SAVANNAH HISTORIC DISTRICT
BOARD OF REVIEW

REQUEST FOR CERTIFICATE OF APPROPRIATENESS

MPC File No.: 26-004689-COA

Address: 313-316 West River Street

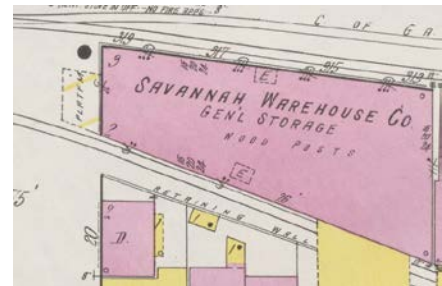
The applicant will be repairing two double-hung windows on the 3rd floor on the north side. The proposed work is consistent with historic district design standards.
